The Able Marine Energy Park Development Consent Order

Planning Inspectorate Reference: TR030001

C.RO Ports Killingholme Limited (Interested Party reference: [REDACTED])

Comments on Written Representations and responses to comments on Relevant Representations

Plan showing section of the Railway beyond AMEP site

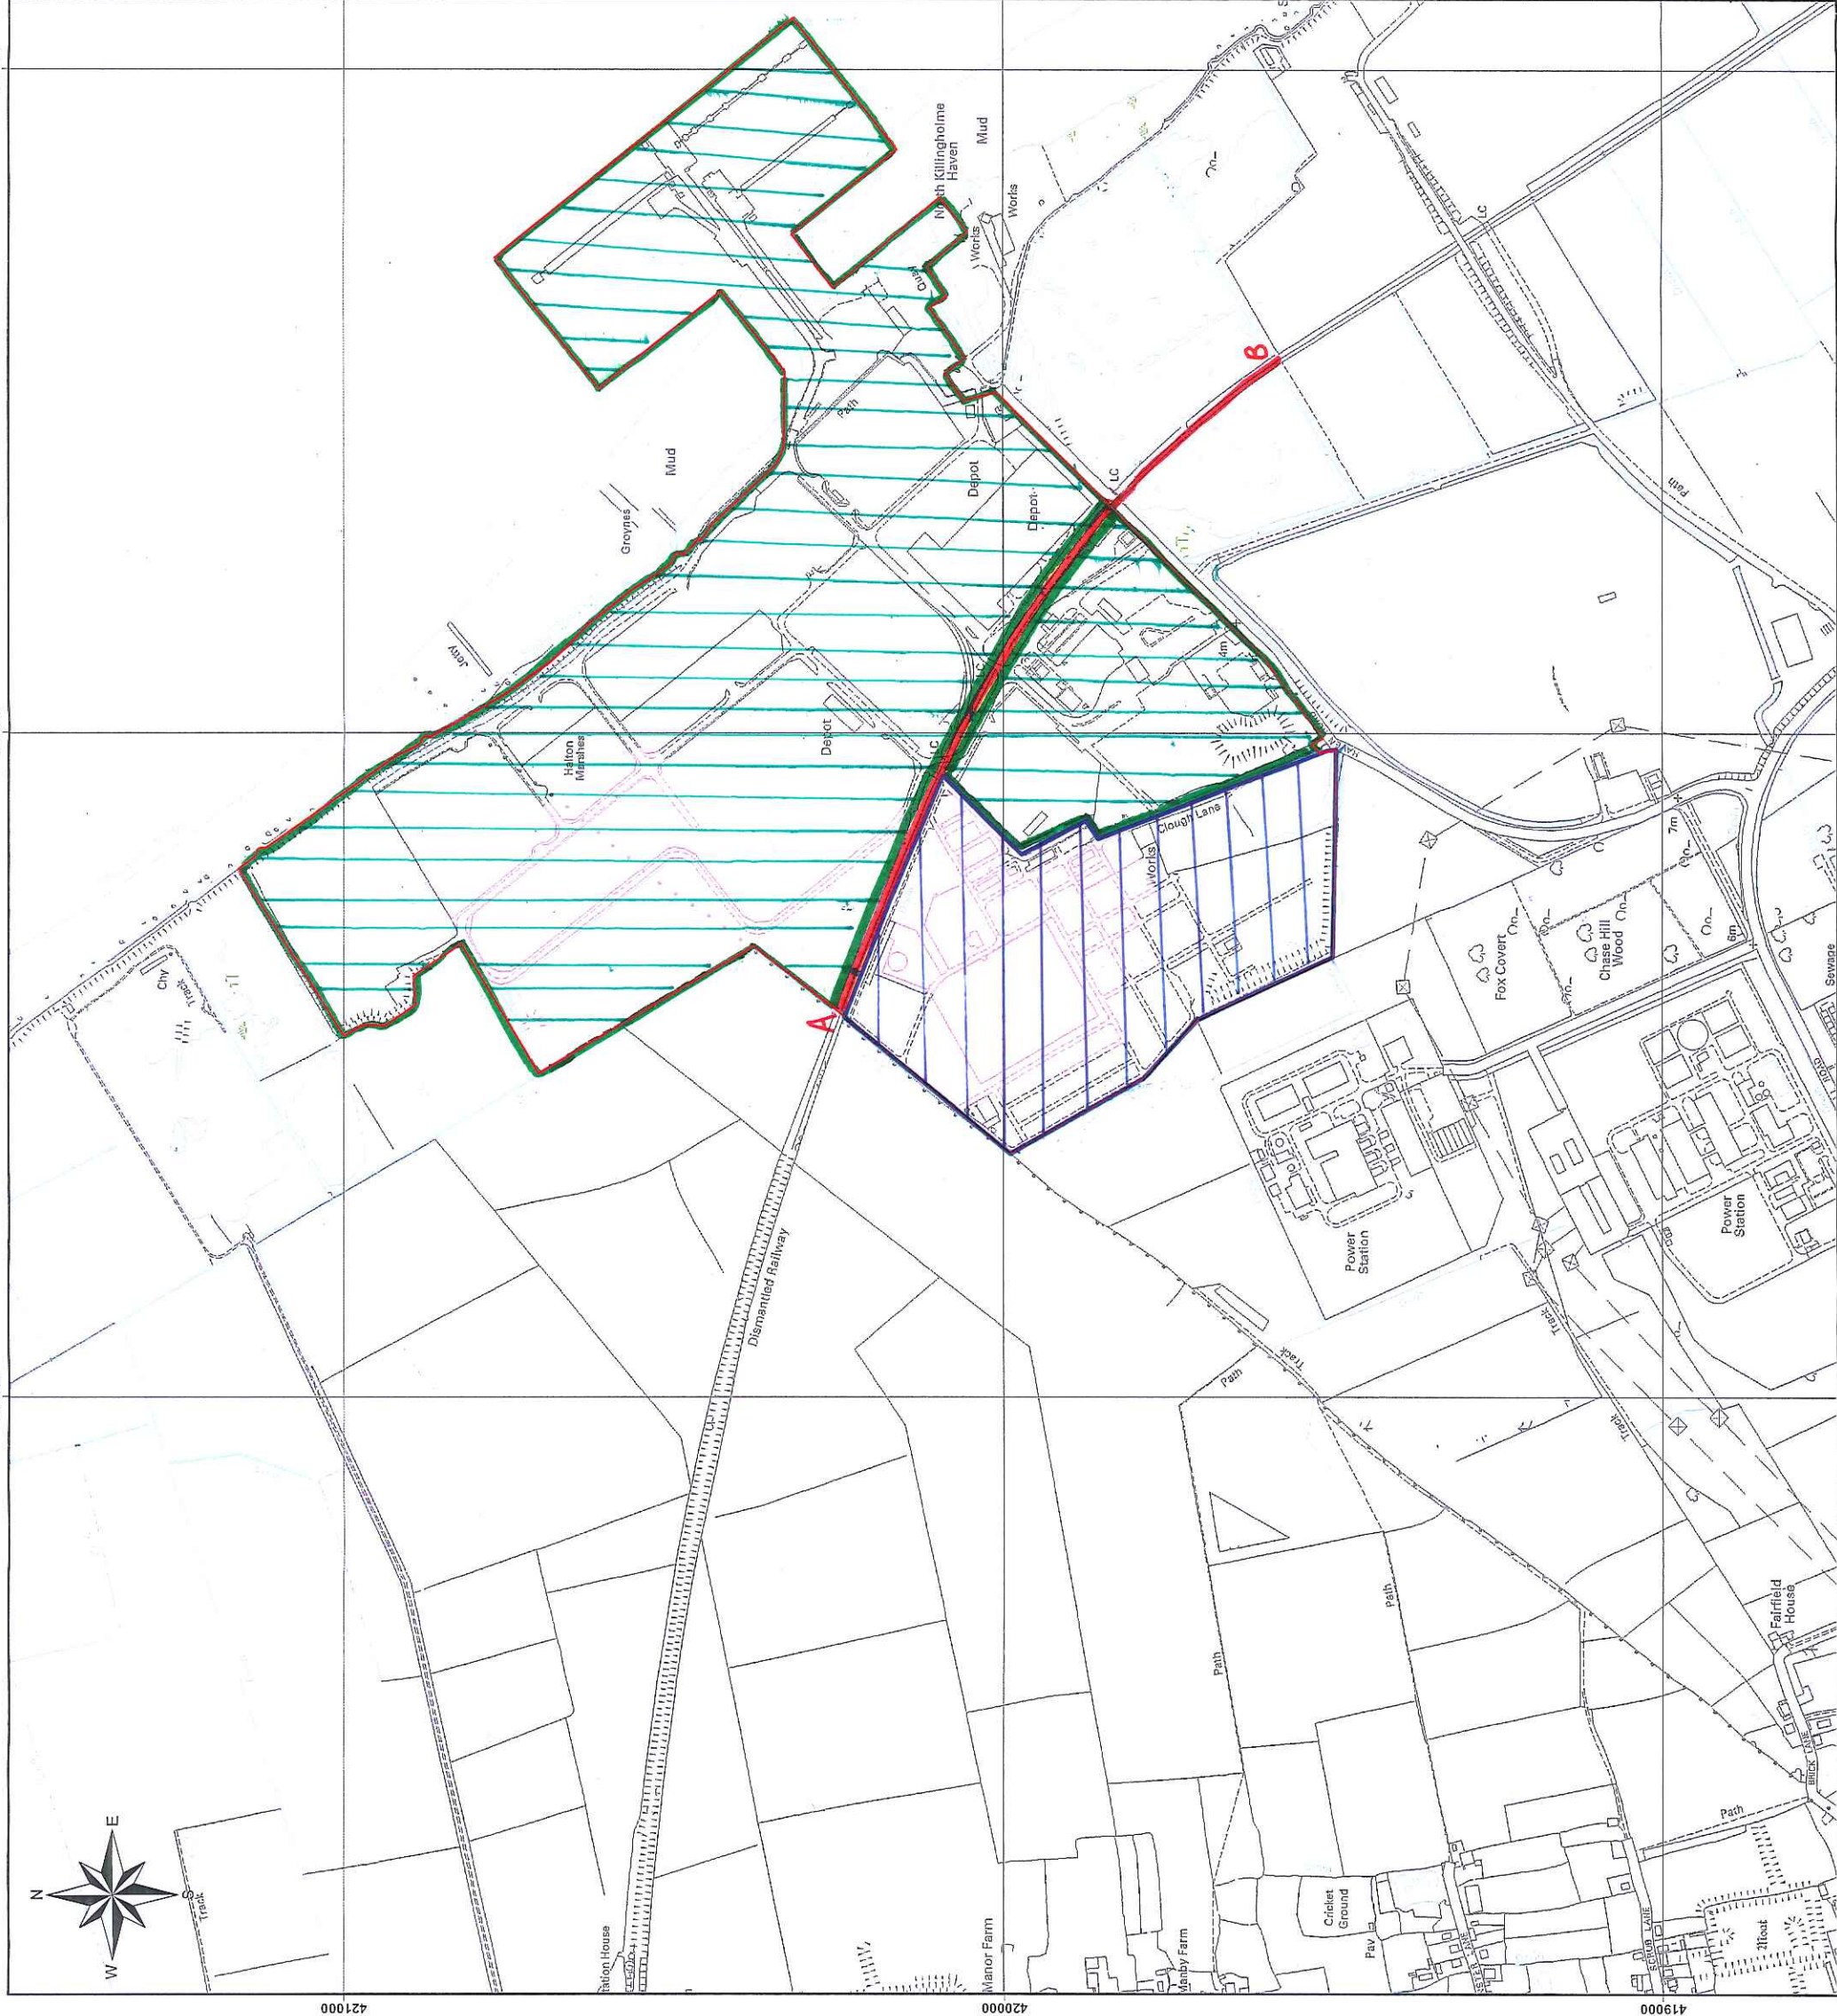
- 4.13 The Examining Authority is also referred to paragraph 13.1 of WR2, which deals with the question of the need for a railway link between AMEP and ALP. If AMEP does not need to use, or have access to, ALP, and there is no intention to secure direct access to it from AMEP, then there can be no justification for the acquisition of the section of the Railway beyond the AMEP site. This section of the Railway is shown by the plan attached at Appendix 2, as the red line between points ("A") and ("B"). The conditions of section 122 PA 2008 are not satisfied. The land is not needed for AMEP and should either be retained in Network Rail's control, or put under C.RO and/or C.GEN Killingholme Limited's control.
